8th Part of Report No. AAEE/896

PEMBROKE C. MK.1 WV.699

RADIO ACCEPTANCE TRIALS

23 FEB 1954

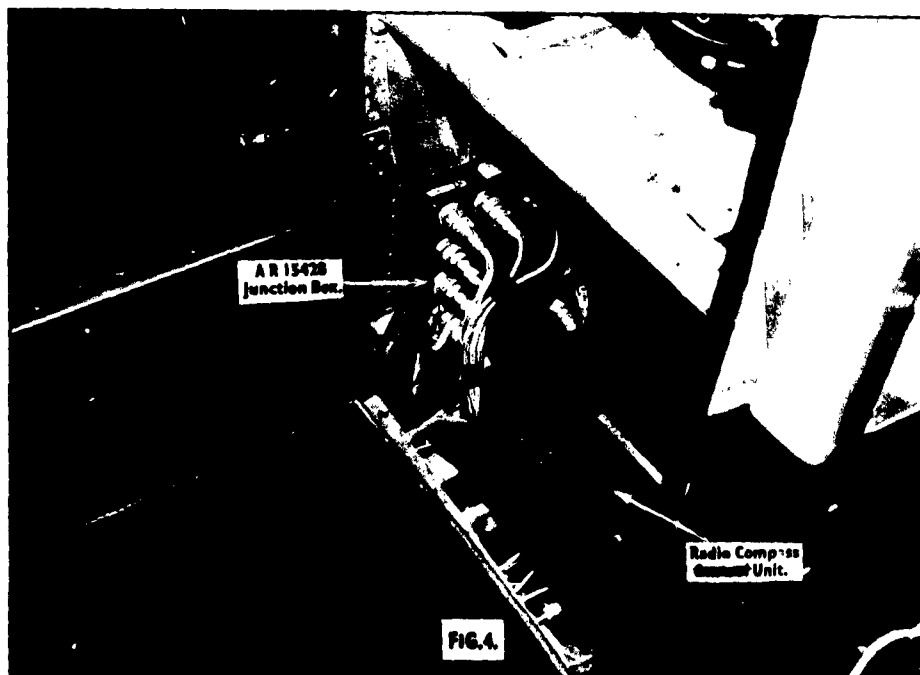
6.1.5. The fixed aerial was suspended between a mast behind the cockpit and the tail fin, (Fig. 3). No provision was made for earthing this aerial.

13.3.3. Provision should be made for earthing the H/F aerial when required. (Para. 6.1.5. refers).

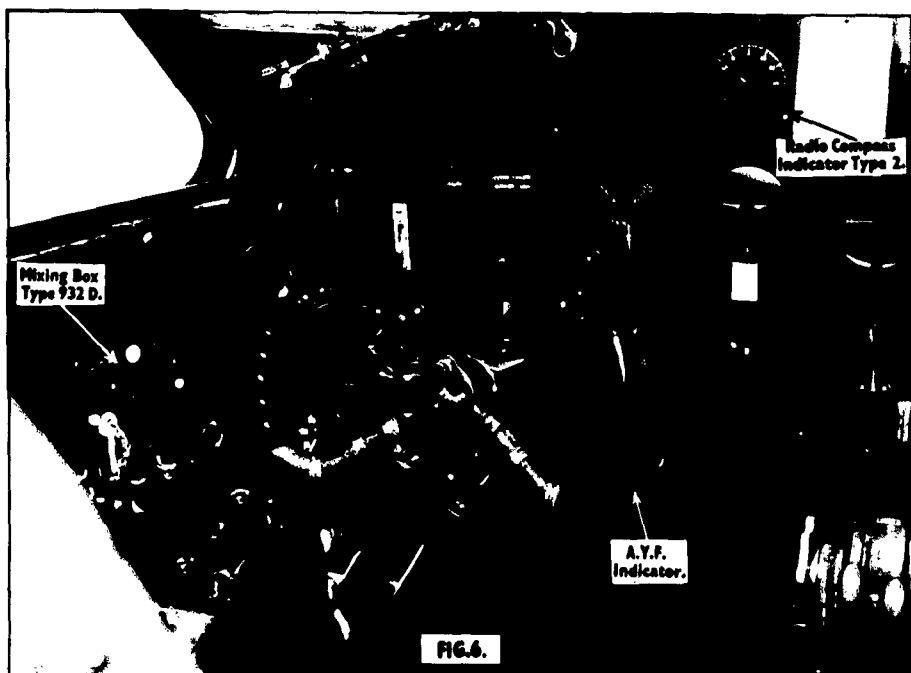
5.1.2. Indicator Type 1, was mounted on the starboard side of the instrument panel below the Rebecca Mk.4 Indicator (Fig. 5). This position was satisfactory, but the flush mounting of the indicator was not entirely satisfactory as errors occurred in the sectors 090° and 270° due to parallax. The reading of the indicator would be facilitated if provision had been made for the indicator to be tilted by approximately 20° .

8.1.3. Indicator type 208 was fitted in the instrument panel on the starboard side (Fig. 5) in a very difficult position for viewing as the observer's head fouled the windscreen wiper. To overcome this bad feature the Indicator should be moved approximately 3 inches to the left and angled upwards.

13.2.1. Repositioning of the A.R.I. 5428 Indicator Type 2, to a position beneath the pilots G4B repeater, would prevent the masking of the top section of the indicator under all conditions. Angling of the indicator Type 1, would enable the operator to read the indicator more accurately (Paras. 5.1.2. and 5.1.3. refer).

13.4.3. The Indicator Type 208 should be moved 3 inches to the left and angled upwards, to improve the viewing position (Para. 8.1.3. refers).

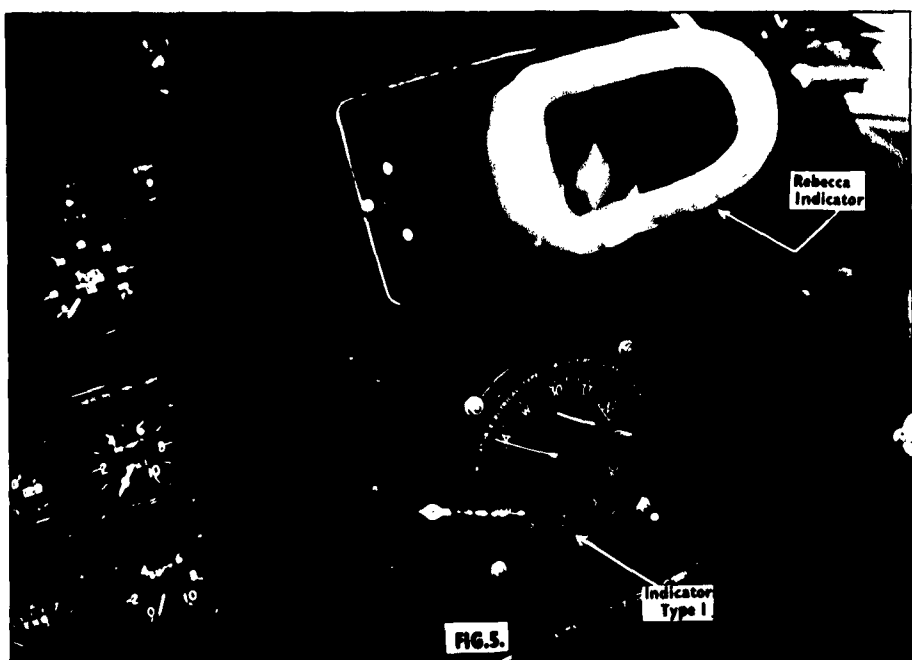
5.1.3. The Indicator Type 2 was mounted on the port side of the instrument panel (Fig. 6). This position was not entirely satisfactory for observation, as the sector 330° to 030° was masked by the instrument light fitting.

10.1.2. The Indicator was mounted on the pilot's instrument panel (Fig. 6) in such a position that at times viewing was restricted by the control column.

13.6.2. The Indicator would be more satisfactory if positioned higher up on the pilot's instrument panel. (Para. 10.12. refers).

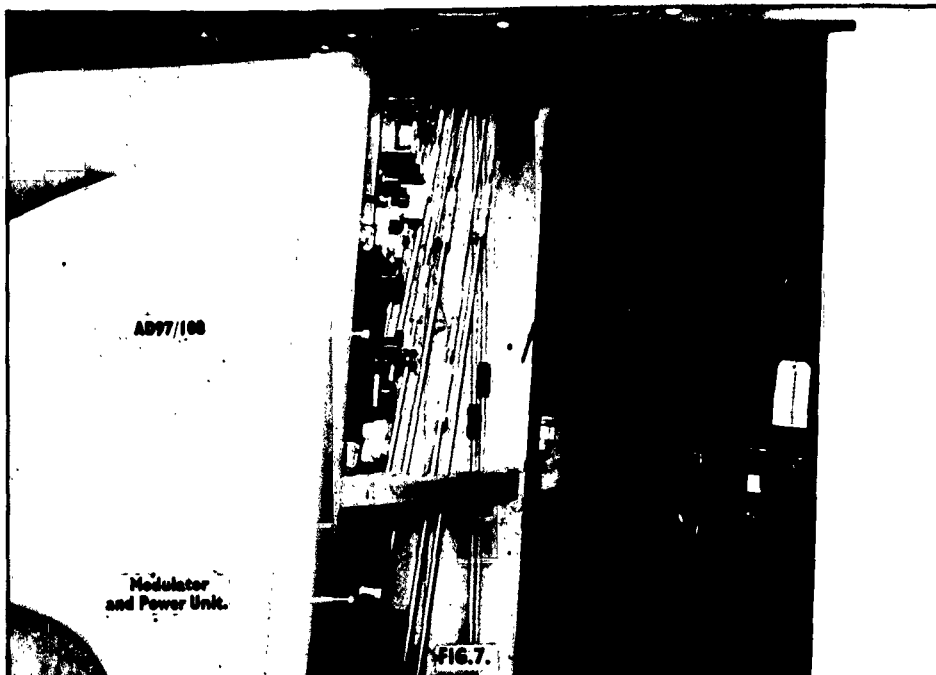
6.1.3. The morse key Type F was mounted on a bracket on the starboard wall of the cockpit, (Fig. 8). This position was not satisfactory for good operating. The provision of a swivelled bracket which could be brought away from the side of the fuselage for operating, and returned to its stowed position when not required would make a better operating position.

6.1.4. The position of the 19 volt power supply switch on the starboard side of the cockpit (Fig. 8) was such that accidental switching on and off could, and did, occur. A cover or locking device should be fitted to this switch.

8.1.2. The control unit type 526 was mounted on the starboard side of the observer's seat (Fig. 8). This position was unsatisfactory, the unit was too far back for the operator to see the controls and very difficult to operate, an improvement could be made by interchanging the control unit with the observer's station box type 931 d.

13.3.1. The use of a hinged bracket for the morse key Type F in lieu of the present fixed bracket would give a better operating position (para. 6.1.3. refers)

13.3.2. A cover or locking device is required to protect the 19 volt supply switch, for the A.D.97/108, being accidentally switched on or off (Para. 6.1.4. refers).

13.4.2. The control unit type 526 should be re-positioned to a more accessible position to facilitate operation (para. 8.1.2. refers).
